Process Sheet

Customer : CC-DAR01 Dart Aerospace Ltd. Drawing Name : D412-742-013
Job Number : 41047
Estimate Number : 10804
P.O. Number :
This Issue : 07/08/2008 S.O. No. :
Prsht Rev. : NC Part Number : D412742013
First Issue : / / Type : LANDING GEAR Drawing Number : DSI 9369/ECN08-510
Previous Run : 41046 Project Number :
Drawing Revision :
Material :
Due Date : 14/08/2008 Qty: 1 Um: Each
Written By :
Checked & Approved By :
Comment :

DART SERVICE INSTRUCTION

DESIGN PH	DRAWN BY AJS	DART AEROSPACE USA, INC. PORT HADLOCK, WA	
CHECKED 	APPROVED	DRAWING NO. DSI 9364	REV. C SHEET 1 OF 1
DATE 08.08.06	TITLE BUSHING INSTALLATION		SCALE NTS
A	07.01.16	NEW ISSUE	
B	07.03.20	ADD TOLERANCE TO 1/2" HOLE	
C	08.08.06	ADDED CHG 005 & SUBS TO EFFECTIVITY

DETAIL A: D3591-1 BUSHING INSTALLATION LOCATION

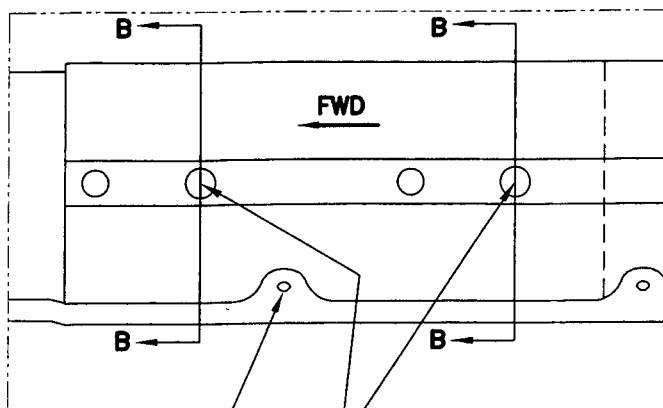
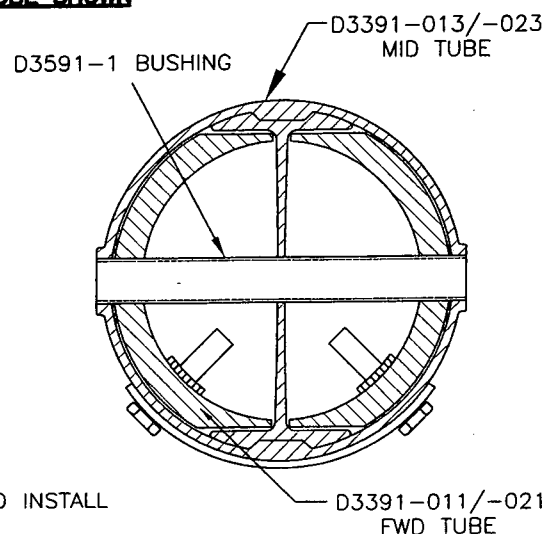
TO PREVENT THE D3391-011/-021 FWD TUBE FROM MOVING WITH RESPECT TO THE D3391-013/-023 MID TUBE, CUSTOMERS RECEIVING D412-742-011/-013 SKIDTUBES AT CHG 002 OR CHG 005 AND SUBSEQUENTS HAVE A D3591-1 BUSHING INSTALLED AT THE FWD SADDLE HOLES AS SHOWN IN DETAIL A (2 PLACES).

CUSTOMERS WITH D412-742-011/-013 SKIDTUBES AT CHG 001, CHG 003 AND CHG 004 CAN PROCURE THE DSI 9364-011 KIT AND INSTALL THE D3591-1 BUSHINGS AS FOLLOWS:

- 1) REMOVE SKIDTUBE/SADDLES FROM AIRCRAFT USING SECTION 32.7 OF ICA-D412-742 AS A GUIDELINE.
- 2) TRANSFER DRILL 1/2" HOLES ($\varnothing 0.500 \pm \begin{smallmatrix} 0.002 \\ 0.000 \end{smallmatrix}$) INTO THE FWD SADDLE HOLES AT THE LOCATIONS SHOWN (2 PLACES) THRU THE D3391-013/-023 MID TUBE AND D3391-011/-021 FWD TUBE. **DO NOT OPEN UP HOLES IN D2571/D2572 FWD SADDLES.**
- 3) REMOVE FWD TUBE FROM MID TUBE, DEBURR DRILLED HOLES, TOUCH UP HOLES WITH MIL-P-85582 OR MIL-P-23377 PRIMER
- 4) RE-INSTALL D3391-011/-021 FWD TUBE INTO D3391-013/-023 MID TUBE USING SECTION 32.7 OF ICA-D412-742 AS A GUIDELINE EXCEPT INSTALL D3591-1 BUSHINGS AS SHOWN IN DETAIL A USING LPS LABORATORIES LPS-3 CORROSION INHIBITOR PRIOR TO INSTALLING THE D2571/D2572 SADDLES.

ENSURE BOLT IS FASTENED PRIOR TO TRANSFER DRILLING (REF)

OPEN TO $\varnothing 0.500 \pm \begin{smallmatrix} 0.006 \\ 0.000 \end{smallmatrix}$ AND INSTALL D3591-1 BUSHING (2 PLACES)

DETAIL A: D3591-1 BUSHING INSTALLATION LOCATION

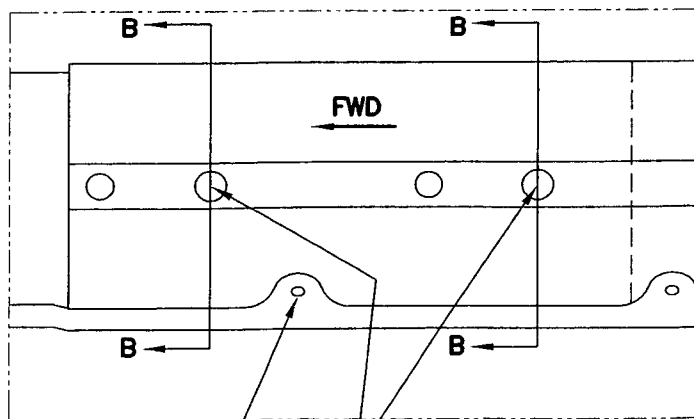
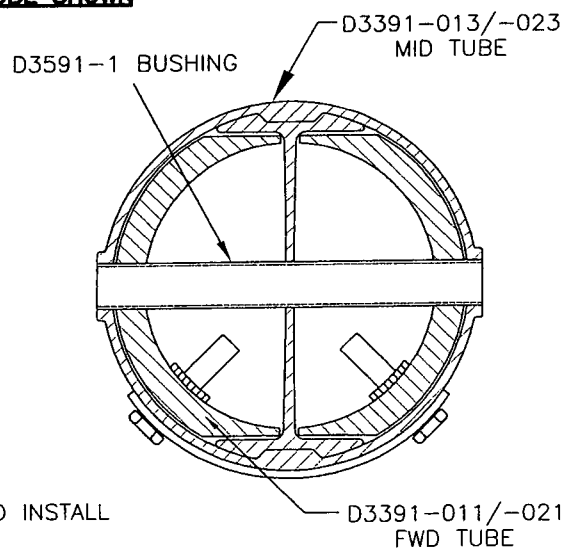
TO PREVENT THE D3391-011/-021 FWD TUBE FROM MOVING WITH RESPECT TO THE D3391-013/-023 MID TUBE, CUSTOMERS RECEIVING D412-742-011/-013 SKIDTUBES AT CHG 002 OR CHG 005 AND SUBSEQUENTS HAVE A D3591-1 BUSHING INSTALLED AT THE FWD SADDLE HOLES AS SHOWN IN DETAIL A (2 PLACES).

CUSTOMERS WITH D412-742-011/-013 SKIDTUBES AT CHG 001, CHG 003 AND CHG 004 CAN PROCURE THE DSI 9364-011 KIT AND INSTALL THE D3591-1 BUSHINGS AS FOLLOWS:

- 1) REMOVE SKIDTUBE/SADDLES FROM AIRCRAFT USING SECTION 32.7 OF ICA-D412-742 AS A GUIDELINE.
- 2) TRANSFER DRILL 1/2" HOLES ($\varnothing 0.500 \pm \begin{smallmatrix} 0.006 \\ 0.000 \end{smallmatrix}$) INTO THE FWD SADDLE HOLES AT THE LOCATIONS SHOWN (2 PLACES) THRU THE D3391-013/-023 MID TUBE AND D3391-011/-021 FWD TUBE. **DO NOT OPEN UP HOLES IN D2571/D2572 FWD SADDLES.**
- 3) REMOVE FWD TUBE FROM MID TUBE, DEBURR DRILLED HOLES, TOUCH UP HOLES WITH MIL-P-85582 OR MIL-P-23377 PRIMER
- 4) RE-INSTALL D3391-011/-021 FWD TUBE INTO D3391-013/-023 MID TUBE USING SECTION 32.7 OF ICA-D412-742 AS A GUIDELINE EXCEPT INSTALL D3591-1 BUSHINGS AS SHOWN IN DETAIL A USING LPS LABORATORIES LPS-3 CORROSION INHIBITOR PRIOR TO INSTALLING THE D2571/D2572 SADDLES.

ENSURE BOLT IS FASTENED PRIOR TO TRANSFER DRILLING (REF)

OPEN TO $\varnothing 0.500 \pm \begin{smallmatrix} 0.006 \\ 0.000 \end{smallmatrix}$ AND INSTALL D3591-1 BUSHING (2 PLACES)
